Agenda for 76th PCCM

76th Protection Coordination Sub-Committee Meeting

Date: 27/02/2025 (Thursday)

B.9 Grid Disturbance in Along and Pasighat areas of Arunachal Pradesh on 23-01-2025 and 05-02-2025:

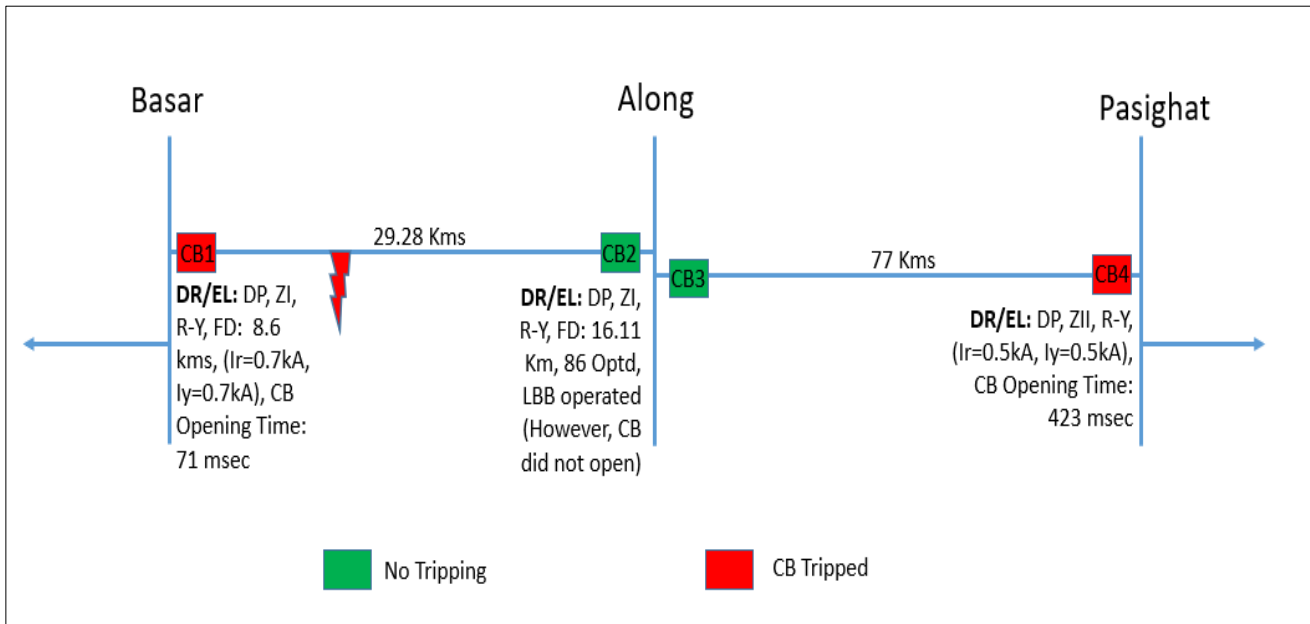
As per DR analysis, R-Y solid fault (Ir-537 A, Iy-535 A) in 132 kV Along-Basar line initiated at 18:36:46.864 Hrs, which was cleared within 80 msec from Basar end on operation of DP, ZI. ZI started from Along end and trip command issued. However, CB at Along fails to open. Non-isolation of fault from Along, resulted in clearing of fault from remote end by tripping of 132 kV Pasighat-Along on DP, ZII, R-Y, within 420 msec.

- Non-opening of CB at Along for 132 kV Along-Basar line despite issuance of ZI trip command. DoP AP to immediately resolve the Pneumatic type Circuit Breaker issue of Basar feeder at Along Substation, which is reported to be in poor working condition.
- DoP AP to implement multiphase along with 1-Ph A/R for continuity of power supply in case of transient multiphase fault.
- At 18:36:47.170 Hrs, after 300 msec of initiation of fault, LBB initiation command was triggered at Along end. However, Pasighat line breaker did not open. LBB time delay setting and its wiring circuit to all feeders at Along to be reviewed and remedial measures to be taken immediately

- SOE not recorded for tripping of any of the elements. The same needs to be checked by DoP AP/SLDC AP/POWERGRID for ensuring IEGC compliance.
- Time drift of 1 min observed at Pasighat end for 132 kV Along-Pasighat line which need to be sync with GPS.

It is to be mentioned that similar kind of disturbance observed on **08th Dec'24** and it was already highlighted in the last 75 PCC meeting. In the meeting DoP Ar. Pradesh apprised that trip command as well as LBB was triggered at Along end, but CB did not operate as it is old and pneumatic. Also, CB3 did not operate on LBB as wiring has not been done yet with LBB. Also, the forum had advised DoP Ar. Pradesh to replace the pneumatic CBs with sprig charged ones at the earliest.

DoP Arunachal may provide an update on the actions taken in response to the aforementioned observations.

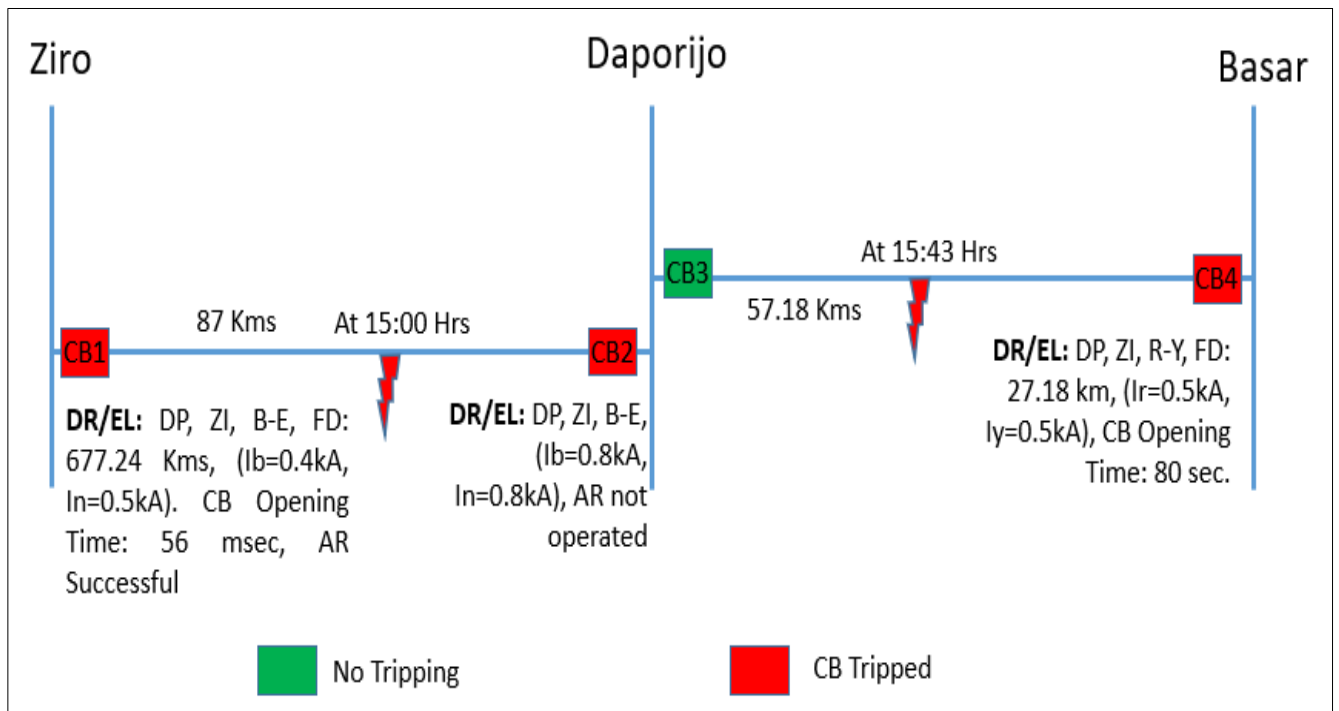
Again at 11:15 Hrs on **5th February'25**, same events occurred due to the non-clearance of fault at Basar for the 132 kV Along Line.

Despite the recommendations provided by the 75 PCC minutes and NERLDC Protection Team vide ref mail 24/01/25 and letter Ref No NERLDC/SO/24-25/14/7384, dated 07/02/25, no corrective actions have been implemented, leading to repeated disturbances caused by the same known issue.

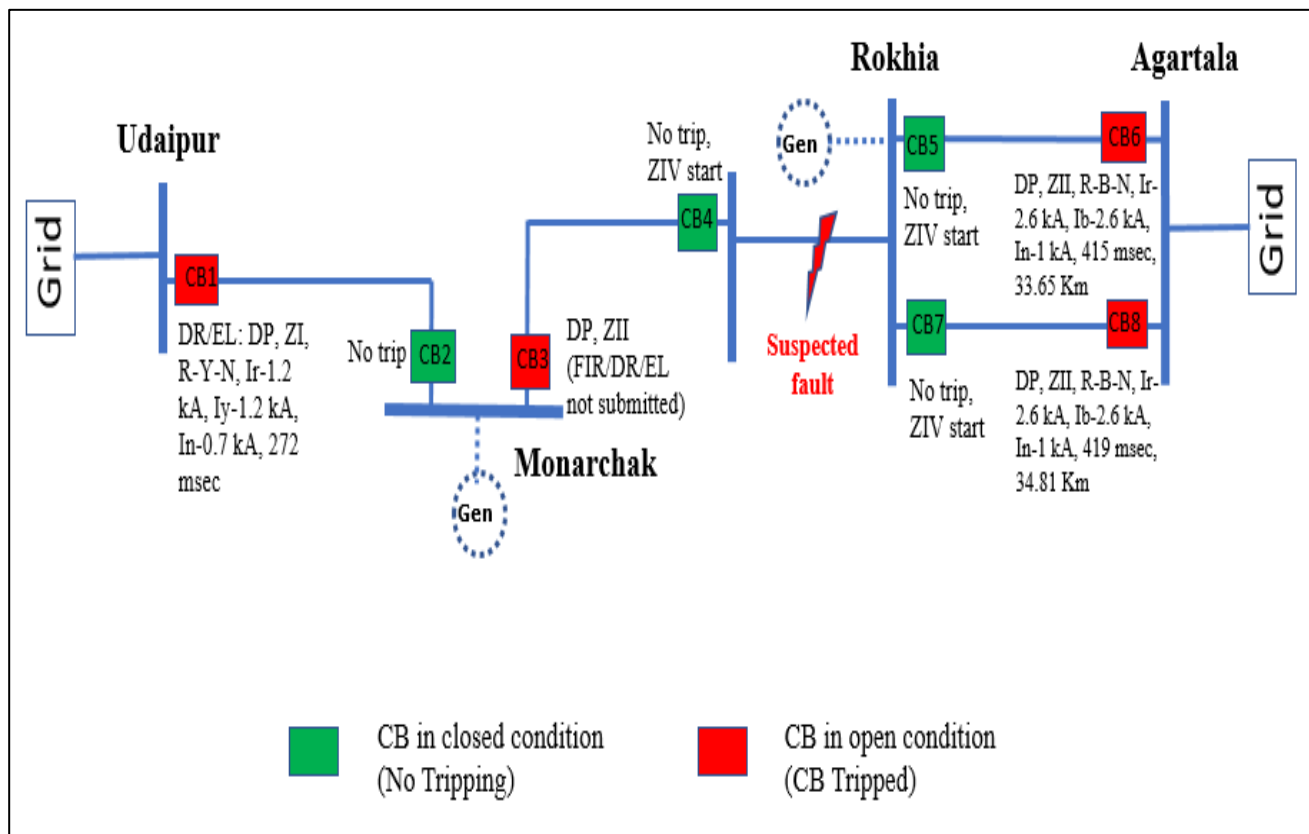
NEEPCO is requested to furnish the reason of Bus bar protection operation at Doyang end and its remedial measures.

In 75th PCCM, NEEPCO informed that there is some issue with the BB protection at Doyang. He further stated that there is urgent requirement of external protection audit at the substation in order to identify all the protection issues, including the issue with the BB protection, and suggest remedial measures.

Forum advised NEEPCO to conduct the BB stability test at the earliest. Forum also suggested that NEEPCO may take support of NTPC in this regard.

Forum also noted that checking of BB protection stability test reports can made a part of FTC procedure for charging of elements.

Fig: Gateway communication process from station to control centre

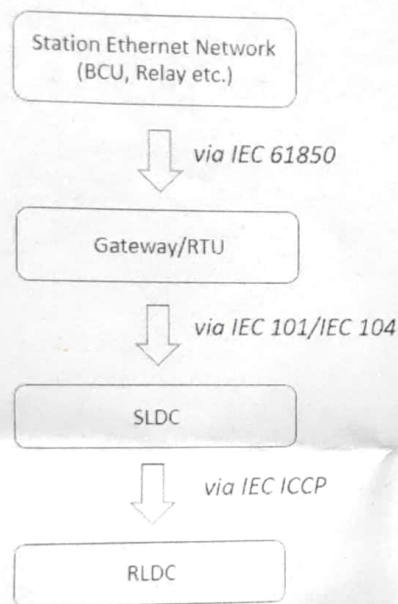
- i) Gateway reporting of Analog and digital signals at AEGCL following the sequence:
The signals from the respective bays are received by the Gateway via IEC 61850 protocol and the signals are then sent to the SLDC via IEC 101 or IEC 104 protocol. The further transmission of signals from SLDC to the RLDC is via IEC ICCP protocol

- ii) The IO Address (IO Address is unique for each signal) is provided by the SCADA team at SLDC and the same is configured at Substation level in the Gateway/RTU system. The IO Address is configured with respect to the IEC 61850 corresponding signals

At field level, after each CT ratio change/upgradation, the current value's verified at BCU and relays by CT primary injection. The Gateway addressing is never affected in such cases.

We request that, NEPRC should consider the above argument and remove Gateway signal validation works during charging permission of elements including CT ratio change/upgradation works

1.1. DR Snapshot of Daporijo for 132kV-Daporijo-Ziro Line

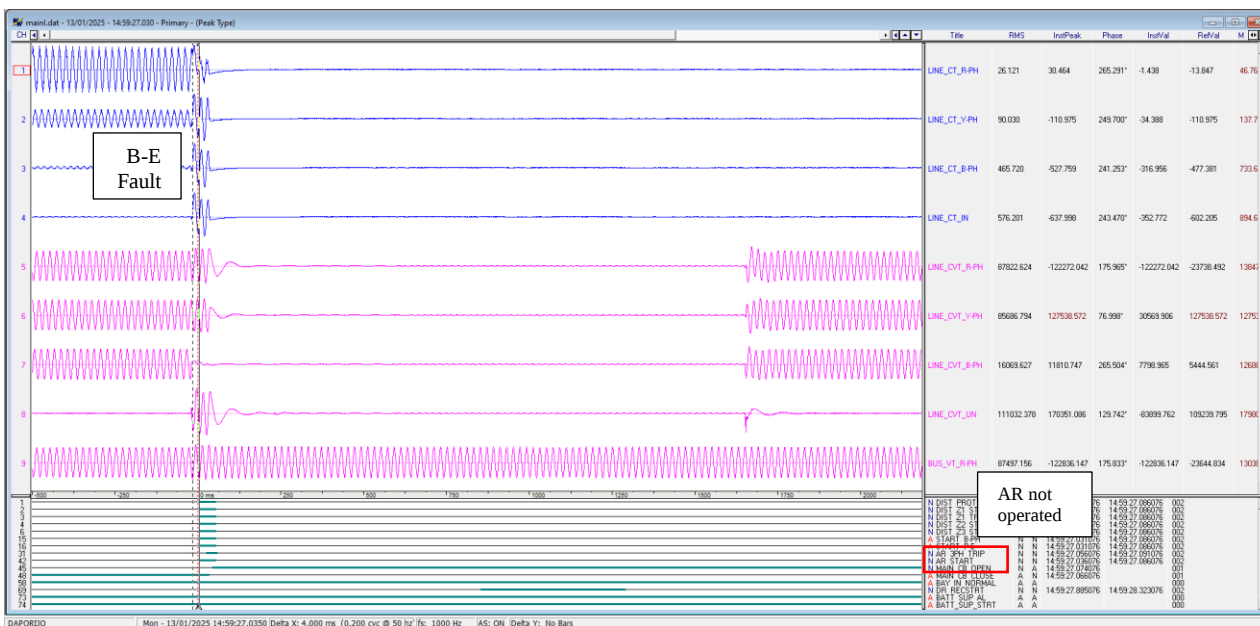
- i) As per DR analysis, B-phase to E fault occurred in 132 kV Ziro-Daporijo Line at 15:00:13.363 Hrs and fault was cleared from Ziro on Z-1 within 57 msec, A/R successfully operated and Daporijo on Z-1 within 56 msec, A/R not attempted.
- ii) At 15:43:18.118 Hrs, another R-Y fault occurred in 132 kV Basar-Daporijo line and fault was cleared from Basar on Z-1 operation within 80 msec. There was no tripping from daporijo as the line is radially feeding from Basar. Due to above Daporijo area isolated from rest of NER grid.

- Regular patrolling and maintenance related activities needs to be carried out as per various CEA/CERC regulations
- Relay setting , A/R scheme need to be review and tested periodically.

2.1. DR Snapshot of Mynkre for 132KV-Myntdu Leshka-Mynkre 2 Line

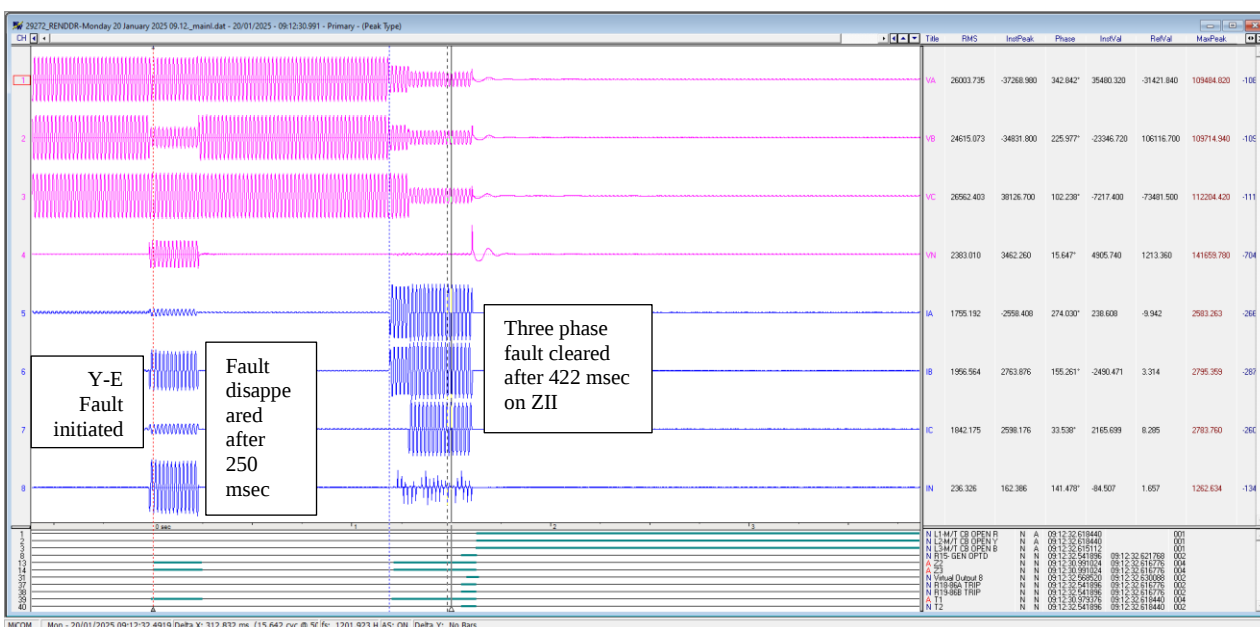
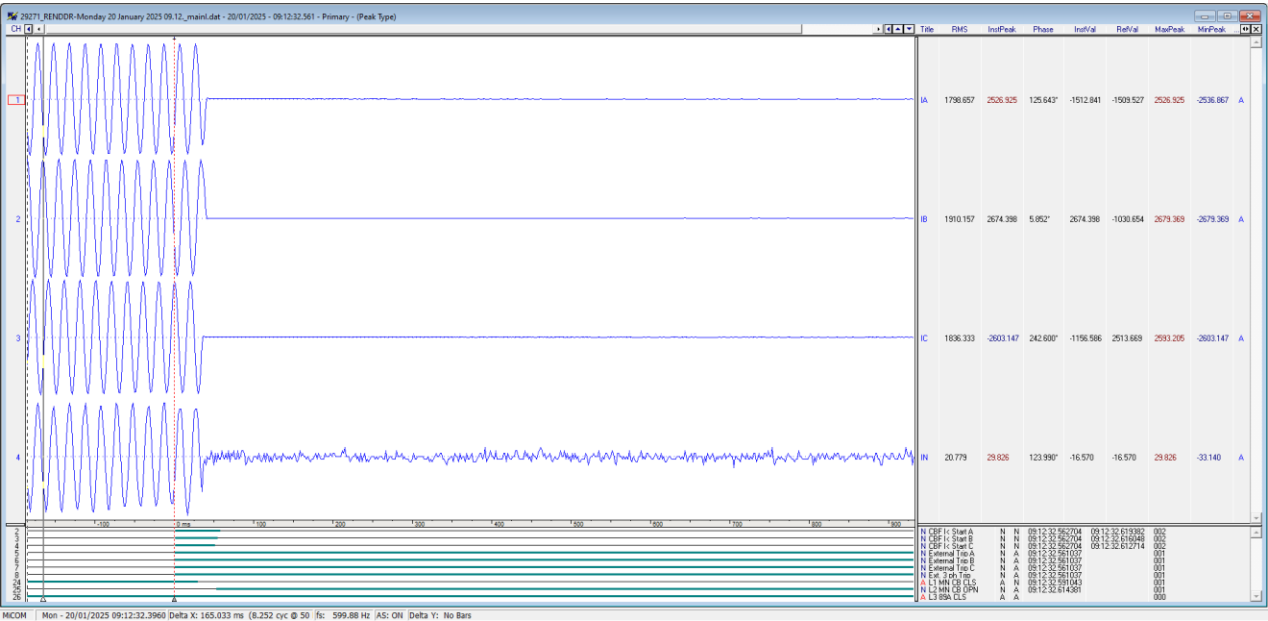
- A huge time drift of 4 mins observed from Mynkre ends DR for 132KV-Myntdu Leshka-Mynkre D/C Lines. GPS need to be checked and time to be aligned to get correct sequence for analysis. Action-MePTCL

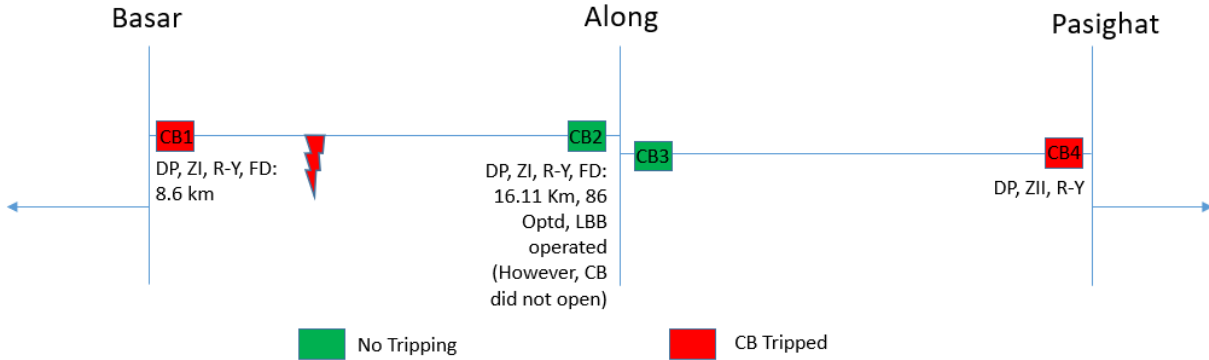
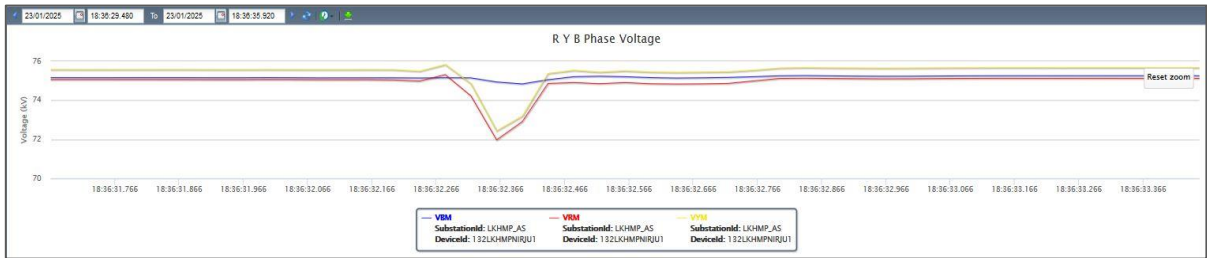
As per DR analysis, R-Y fault (Ir-537 A, Iy-535 A) in 132 kV Along-Basar line initiated at 18:36:46.864 Hrs which was cleared within 80 msec from Basar end on operation of DP, ZI. A/R not attempted. ZI started from Along end and trip command issued. However, CB at Along did not open. Due to non-isolation of fault from Along, fault was feeding continuously from Pasighat of 132 kV Pasighat-Along line and cleared the fault on DP, ZII, R-Y, within 420 msec, resulting blackout of Along area. No tripping from Along end.

At 18:36:47.170 Hrs, after 300 msec of initiation of fault, LBB initiation command was also triggered at Along, however the Pasighat line breaker did not open.
